STAFF REPORT TO COMMITTEE

MEETING TYPE & DATE: Electoral Area Services Committee of March 4, 2026

SUBJECT: Application No. RZ24A02 (746, 750, 754, 760 and 766 Handy Road and 2673 and 2691 Mill Bay Road; PIDs: 001-293-648, 000-697-770, 001-293-630, 001-293-621, 001-293-613, 001-349-325, 001-293-605)

FILE: RZ24A02

sheet title
Parkade Plan

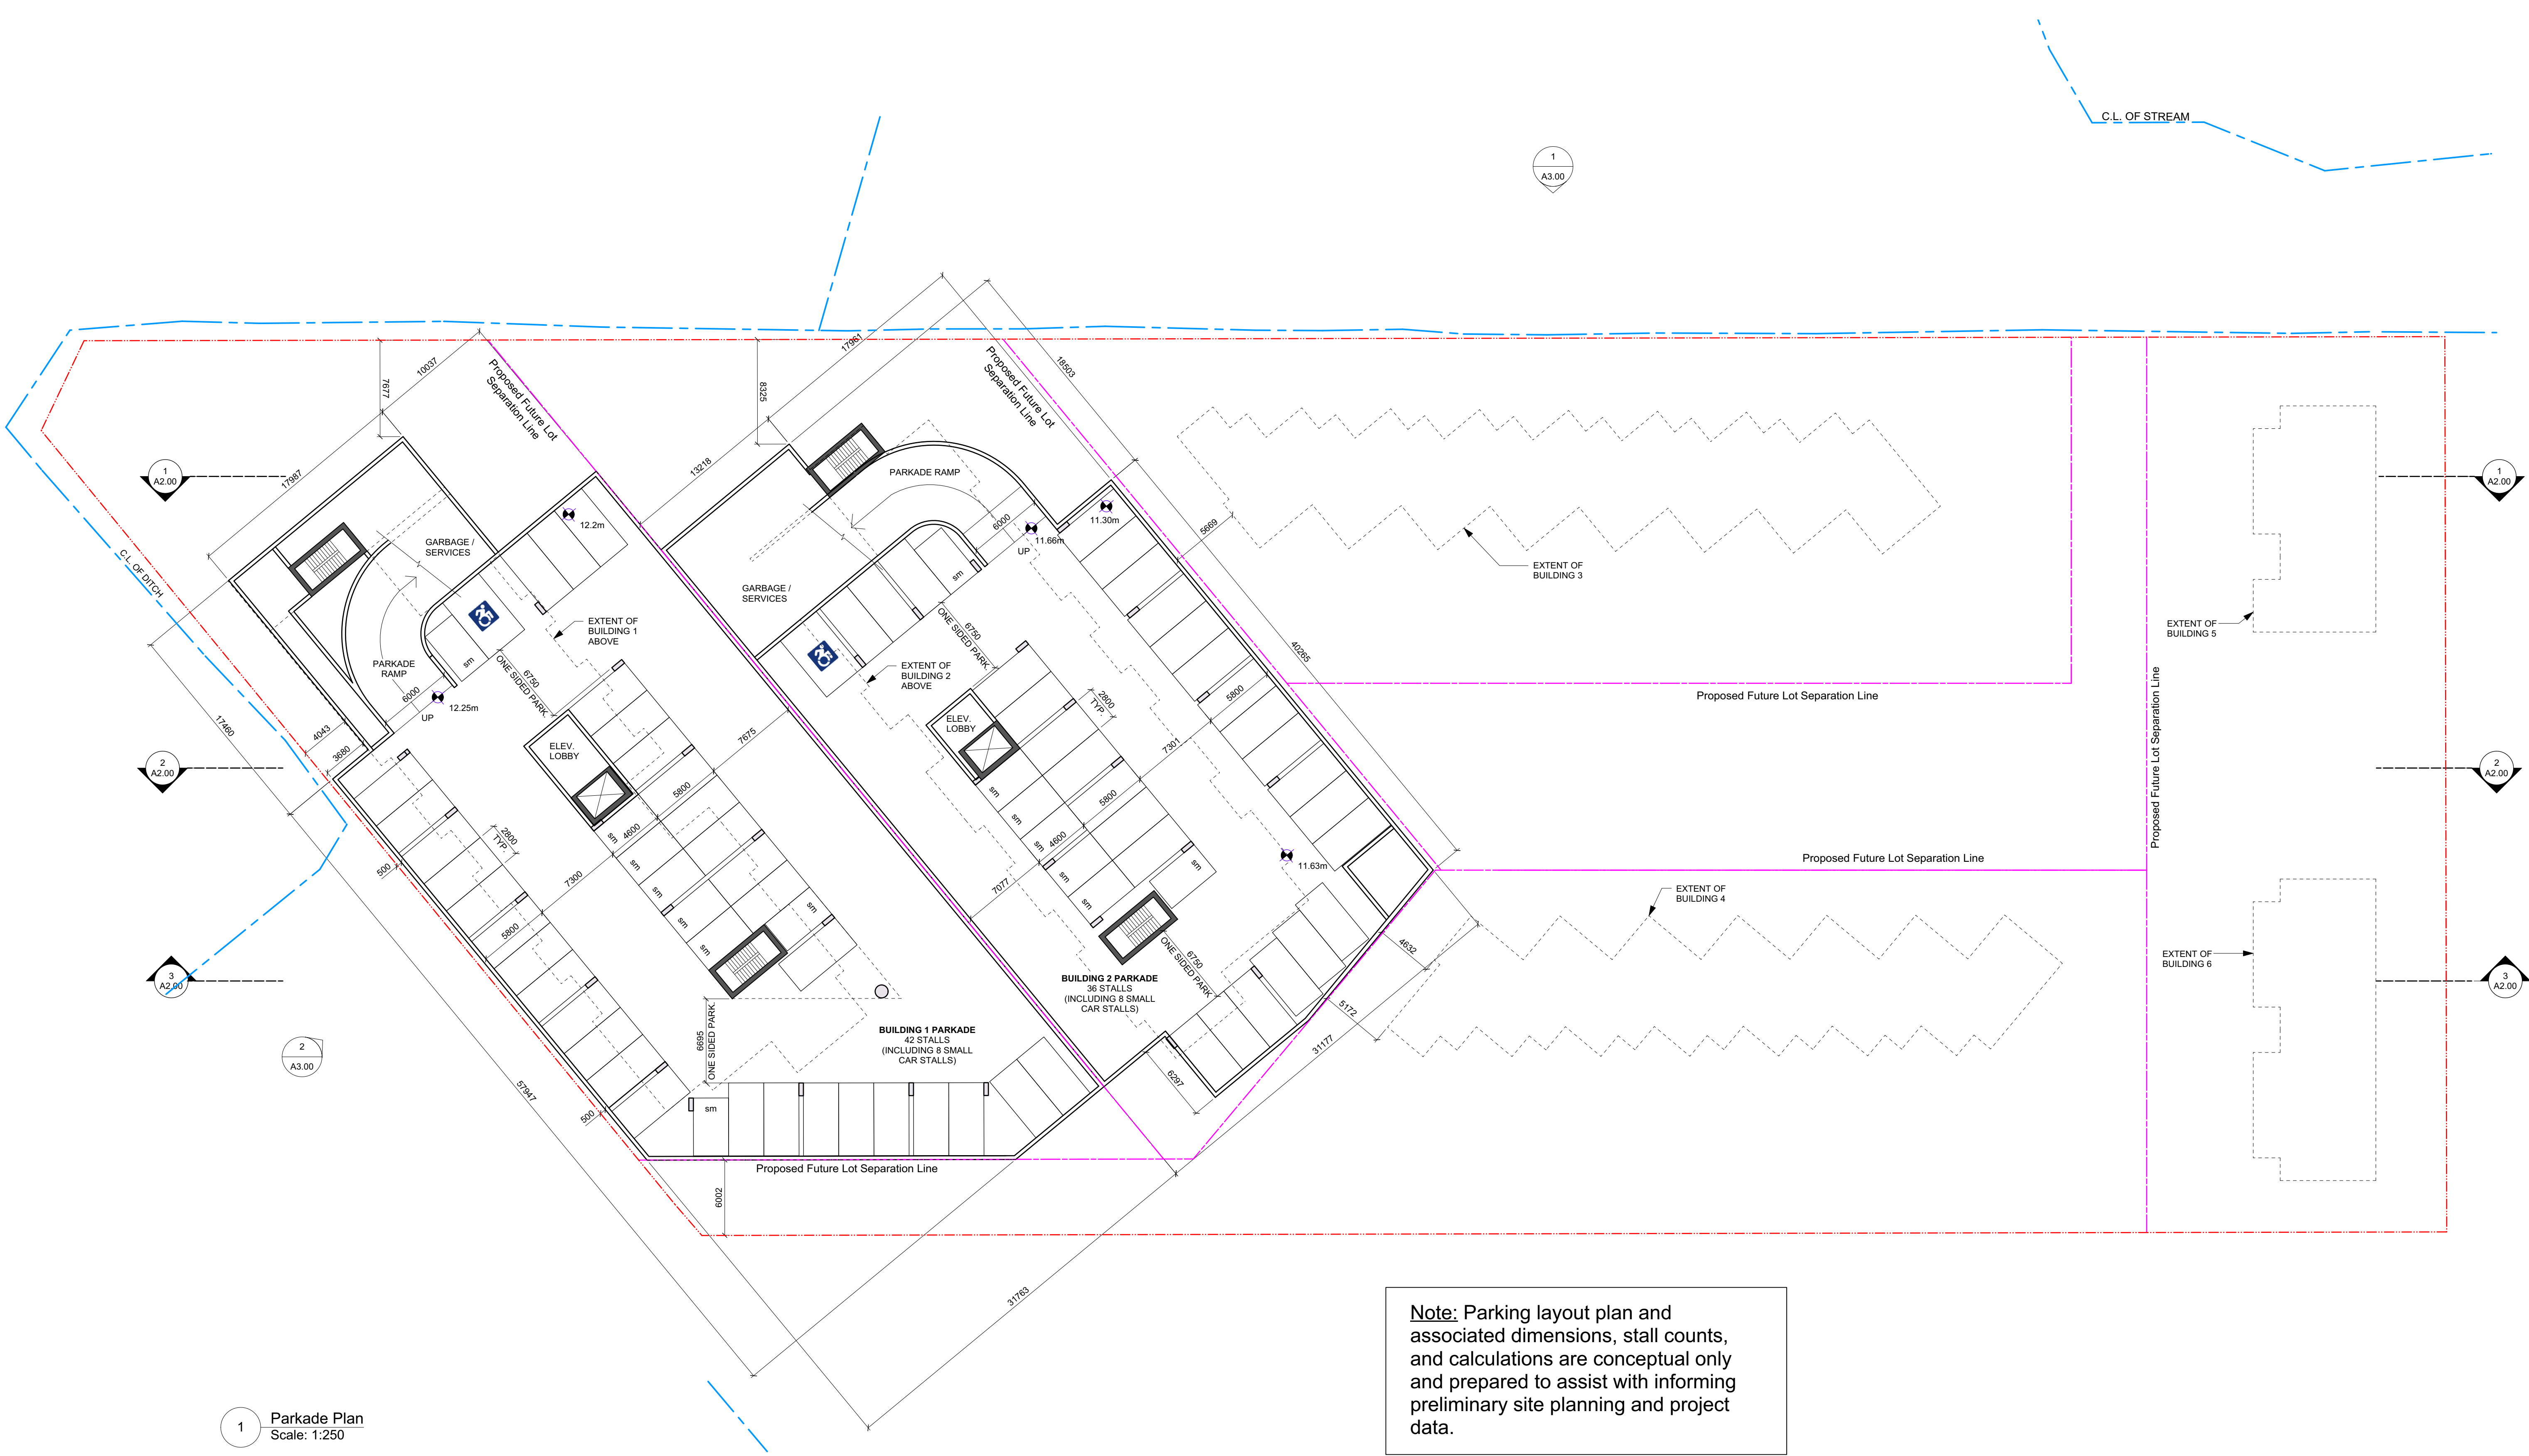
Based on the current Zoning Bylaw, the Parking Study estimates a total of 168 to 192 onsite spaces are required for the proposed apartment buildings. However, the Parking Study estimates that parking demand will be less than this and estimate demand to be one (1) vehicle space per unit – therefore, according to the Parking Study only 122 to 144 onsite spaces will be needed for the proposed apartments. The current plan proposes 108 spaces (underground and surface) for the apartment buildings.

While the plan demonstrates that onsite parking can be provided for the 22 proposed townhouses, it does not meet the required onsite parking for the proposed apartment buildings. MoTT staff have stated they will not support on-street parking.

In addition, the plan does not account for the distribution of bedroom units, which will increase the required number of onsite parking spaces. As a result, the total required onsite parking for the proposed development cannot be determined at this time. The applicant has recently indicated they will meet parking requirements at the Development Permit stage.

1. Increase the proposed supply of vehicle parking for the multi-family apartment buildings to 1.0 spaces per unit, based on 0.90 spaces per unit for residential parking and 0.10 spaces per unit for visitors.
2. Provide bicycle parking spaces at a rate of 1 space per unit.
3. Explore additional TDM measures outlined in Section 6.0 as required to further reduce any outstanding demand to align with the proposed supply.
